# Canterbury Bankstown Council TRANSGRID EIS Response

Council acknowledges the EIS and provide the following commentary.

**Figure 5-6 The cable bridge across the river will have a significant visual impact and have associate direct and indirect impacts on the mangrove forest.**

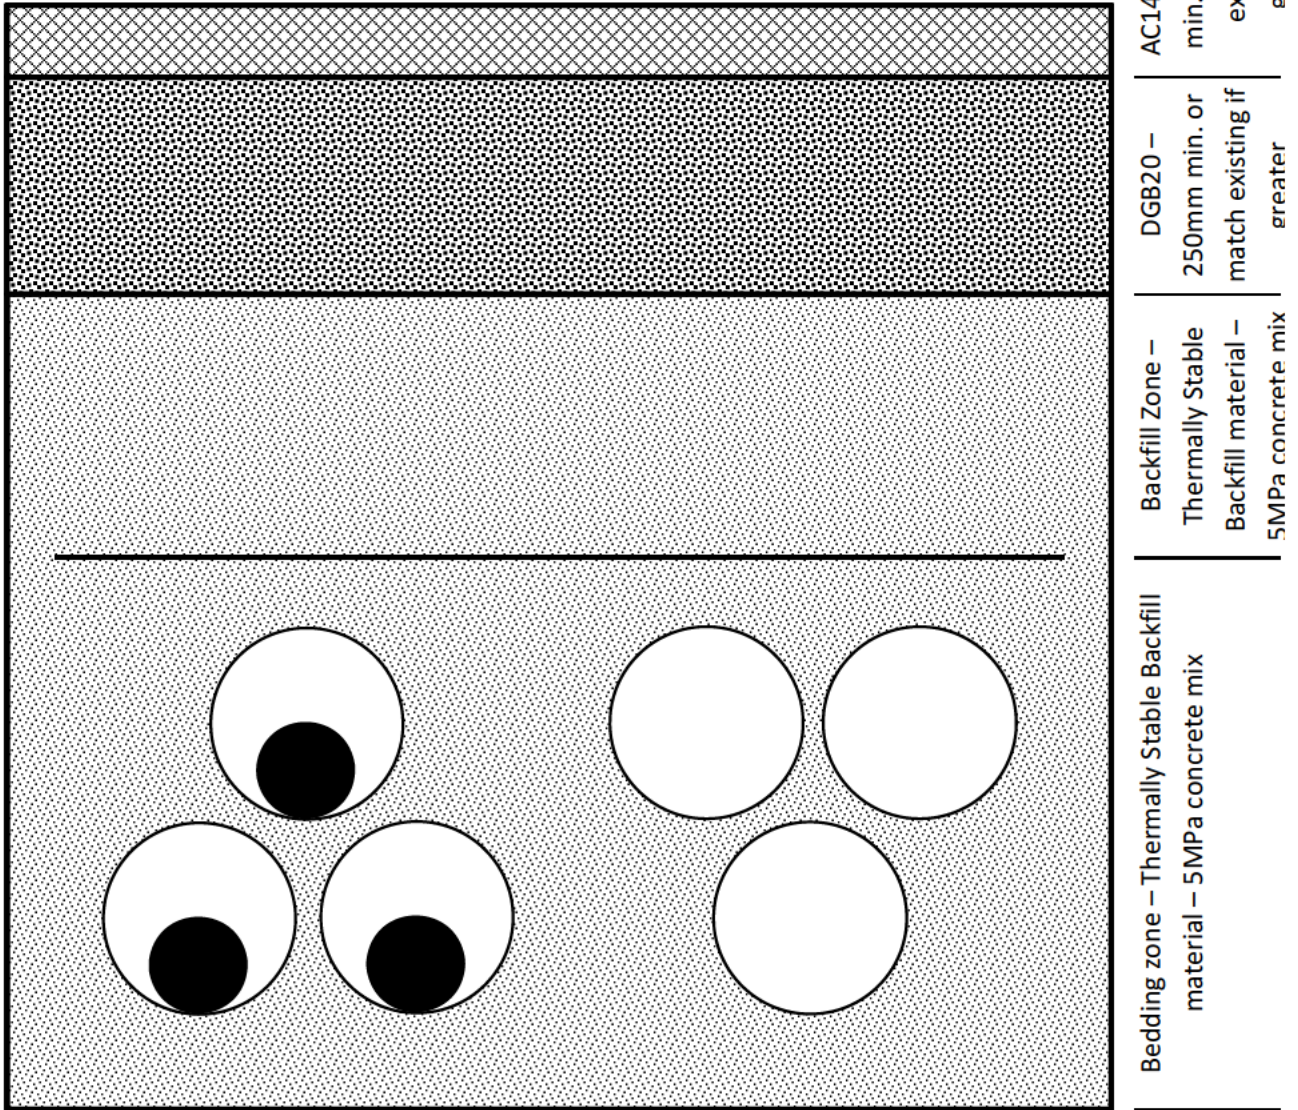
Council advises that an above ground crossing in the form of a conduit only bridge is **not** supported.

Council will not support a joint facility bridge, ie incorporating both TRANSGRID and public use. Thus Council position is for **no** above ground crossing of the river.

Council position is a below ground crossing of the river, with the route south of the river restricted to the road reserves and not traverse Mildura Reserve, or the Cooks River foreshore,

**Semi-Permanent Restoration – for flexible pavement carriageway**

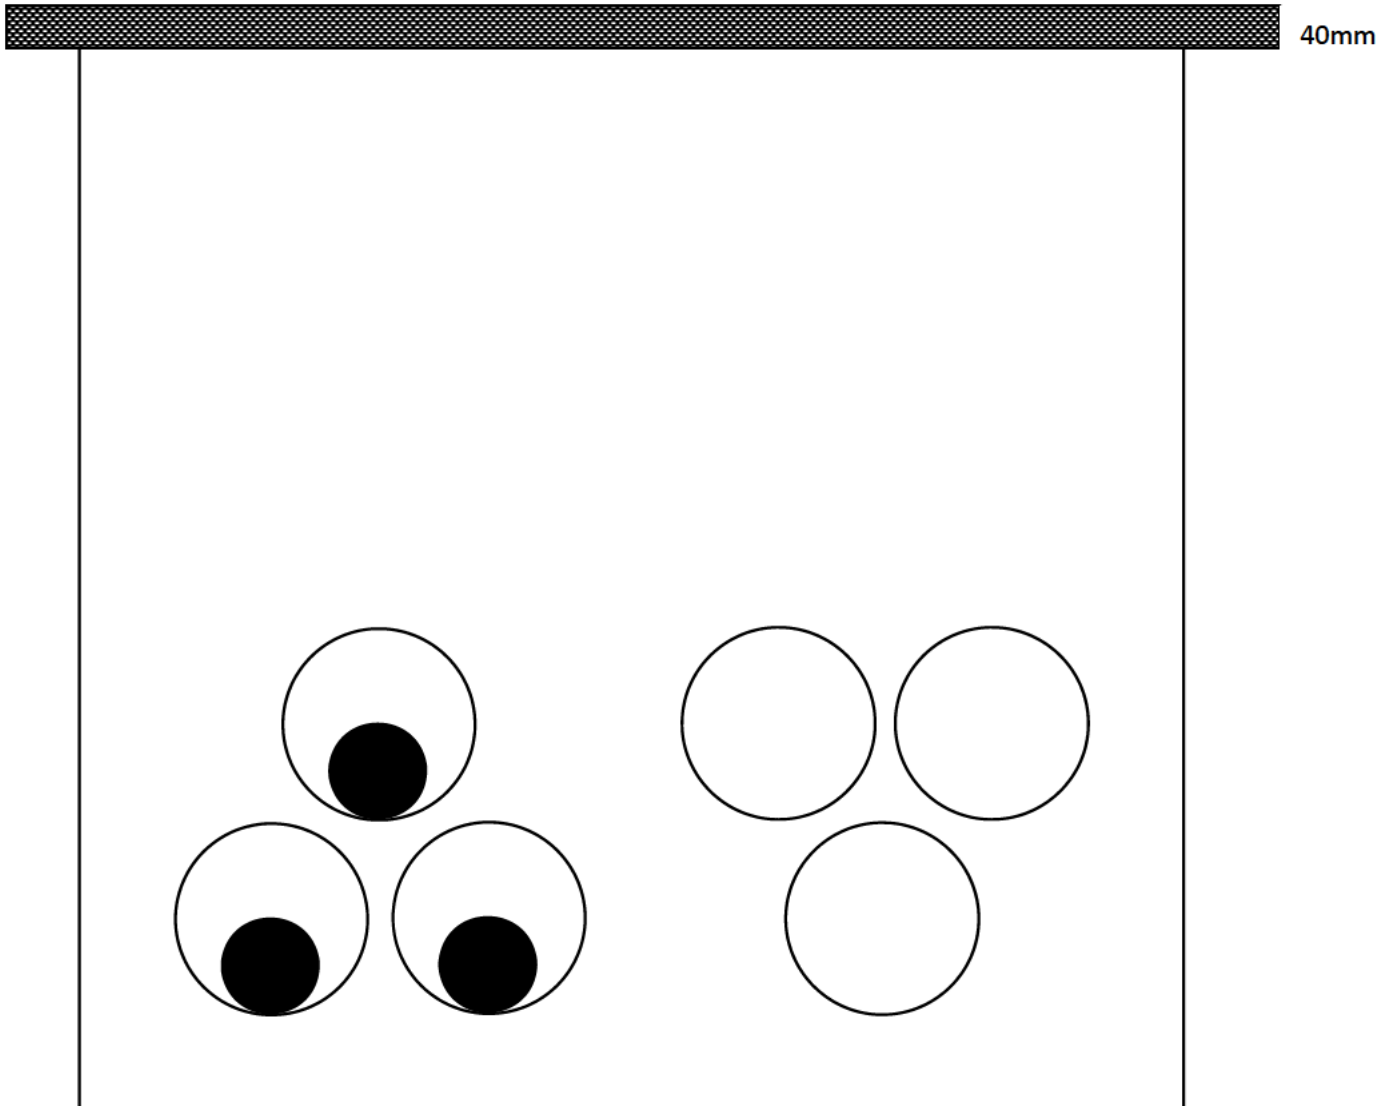
Final width to be determined following walk through of each street by Council Officer and TransGrid Officer – Typically a minimum of 300mm cutback is required on the wearing course on either trench edge

**Permanent Restoration – for flexible pavement carriageway**

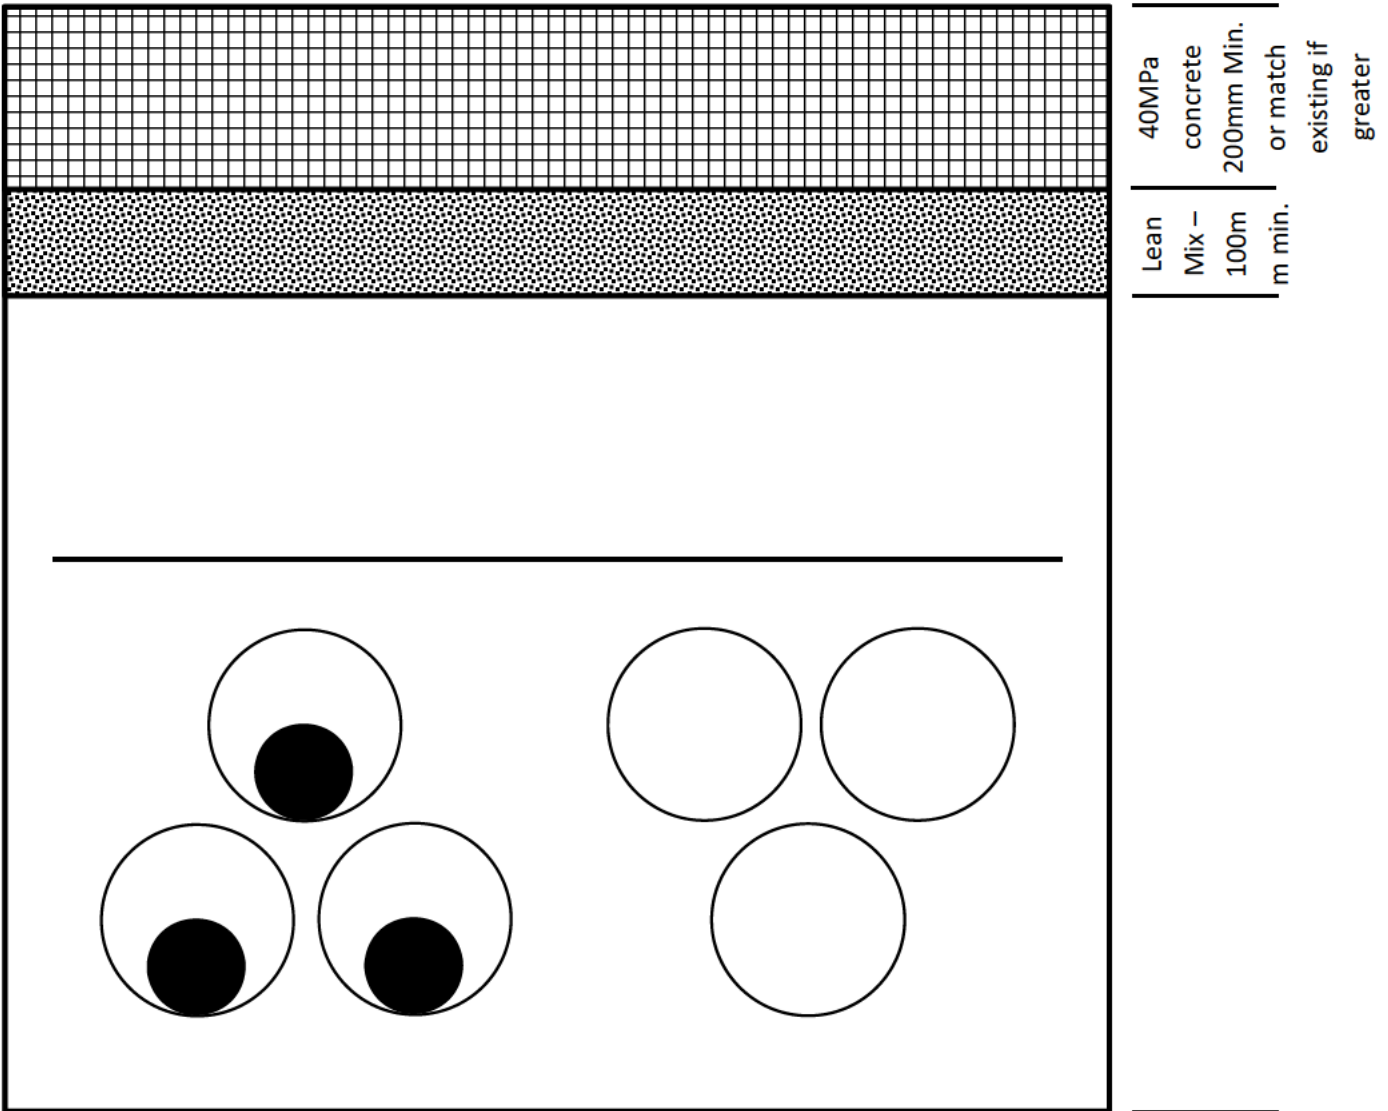
Mill & Pave undertaken to depth of 40mm across trench width and margin either side, considering alignment of trench on a street by street basis, condition of existing pavement including over break, etc.

Final width to be determined following walk through of each street by Council Officer and TransGrid Officer – Typically a minimum width will be trench width or compliance with RMS M209 - dependent on the proximity to longitudinal joints.

**Effect on Drainage Infrastructure – possible sterilisation of road reserves to accommodate drainage augmentation.**

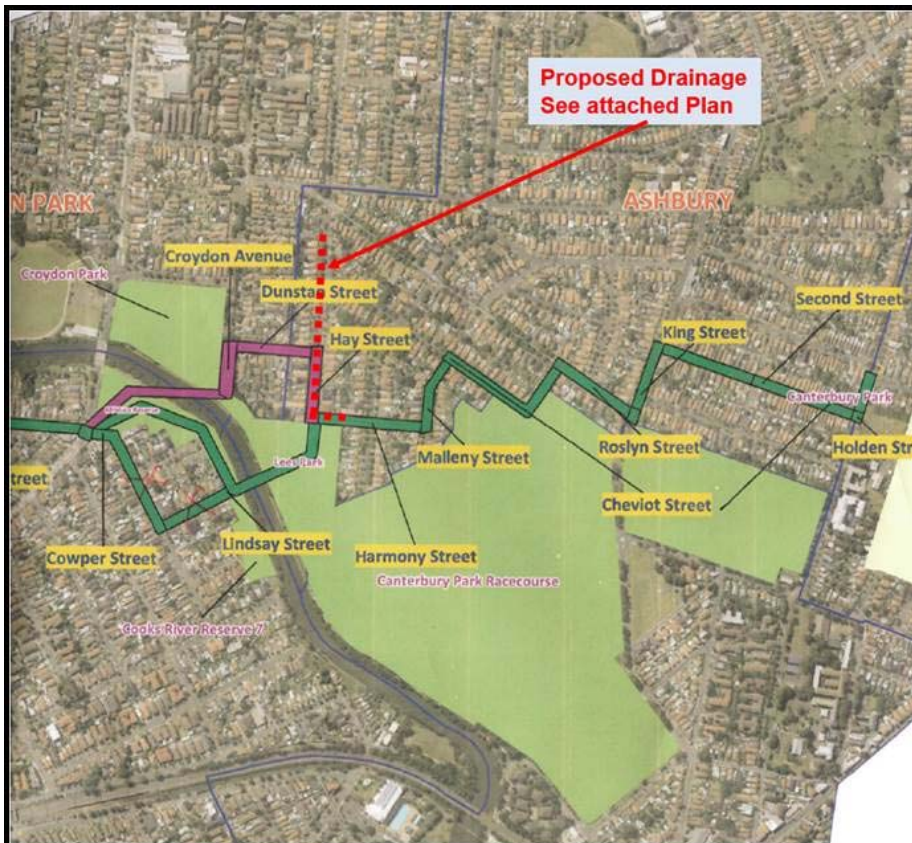
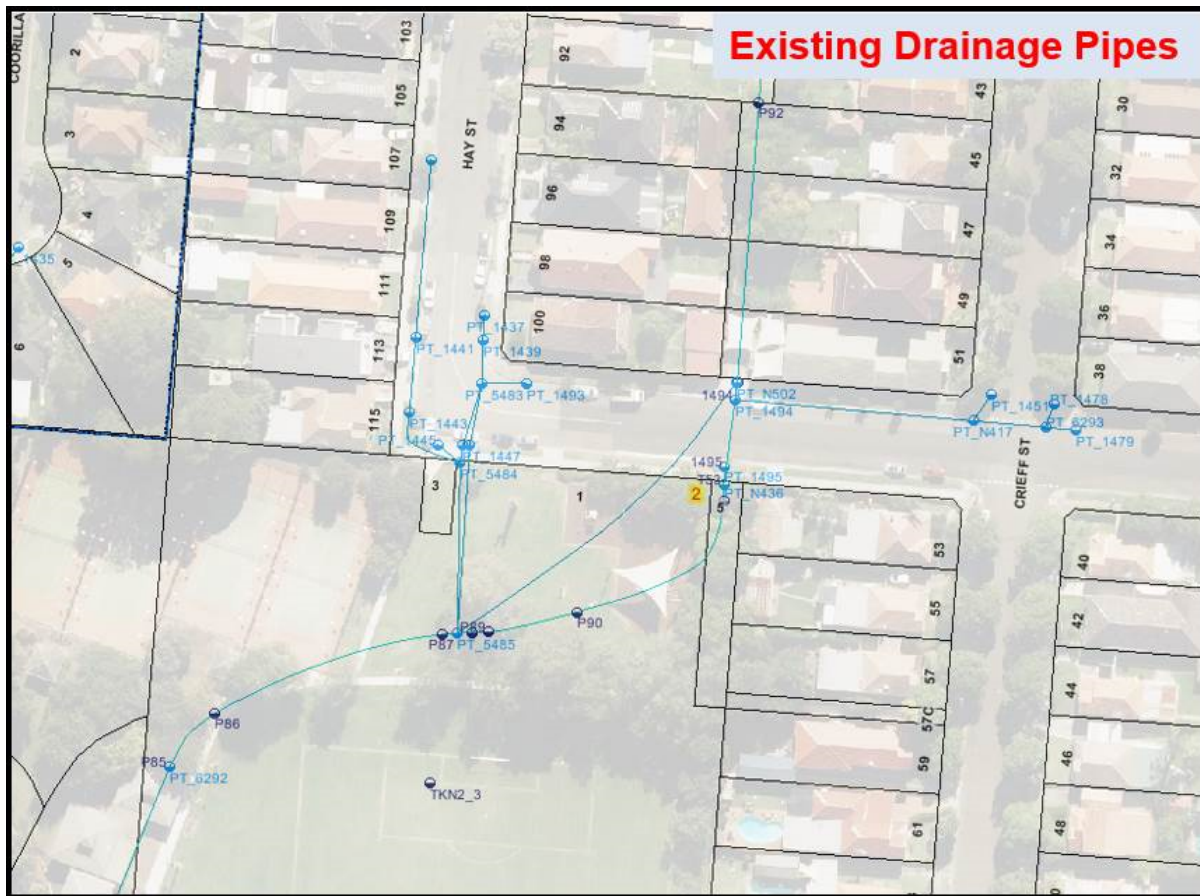
The inclusion of the proposed electrical conduit and associated protective trenching will limit the capacity of the road reserve to accommodate future service upgrades.

This can be especially problematic in terms of drainage augmentation.

It is advised that Council shall be consulted on the proposed location of the works, both horizontally and vertically to ensure the proposed works do not sterilise the road reserve from future drainage upgrades. This consultation/coordination shall be undertaken a minimum of 3 months prior to on ground commencement of the project.
